# Technical Service Information

## FORD/MAZDA CD4E PERSISTENT GEAR RATIO ERROR OR TCC SLIP CODES

Figure 2

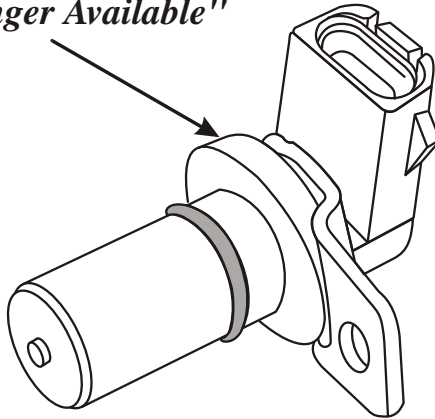
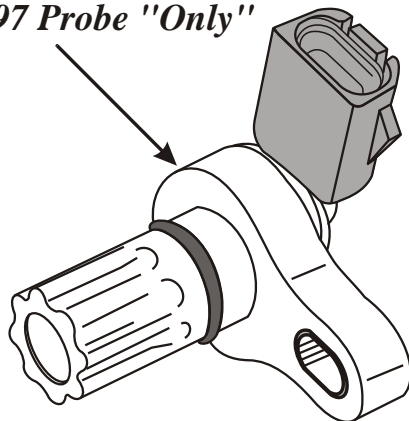
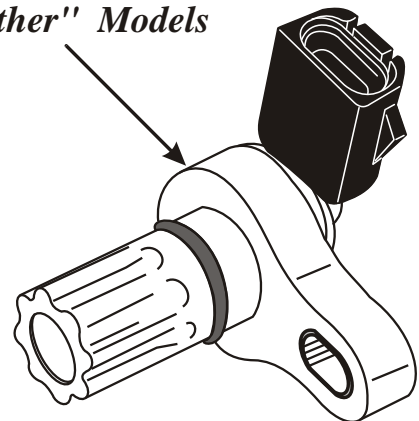
**CAUSE:** *The cause, believe it or not, is the replacement Turbine Speed Sensor.* The replacement TSS was redesigned and has an *enclosed* pickup as seen in Figure 2. The previous design TSS has an *exposed* pickup also seen in Figure 2. It seems, when the pickup was enclosed, the air gap between the TSS and the reverse clutch hub was increased. When the signal was checked and compared to the previous sensor signal, the new sensor signal exhibited a voltage difference but, when checked with an oscilloscope the previous sensor puts out a wider pattern than the current design sensor which means, the computer has more time to read the signal with the previous design sensor. In other words, with the current design turbine sensor, the computer does not have enough time to read the signal and may miss alternate signal pulses which causes the above complaint, on some models only.

**CORRECTION:** Ford Motor Co. has now released a new design white TSS with a "green" connector that is to be used on 1994-1997 Probe vehicles, as shown in Figure 2. The new design white TSS with the "black" connector is to be used on "All Other" models using the CD4E transaxle, as shown in Figure 2. Install the proper TSS depending on the model that you are working on and service part numbers are shown below.

Turbine Shaft Sensor, 1994-1997 Probe Only, Green Connector ..... F7RZ-7M101-KA  
Turbine Shaft Sensor, All Other Models, Black Connector ..... 1S7Z-7M101KA
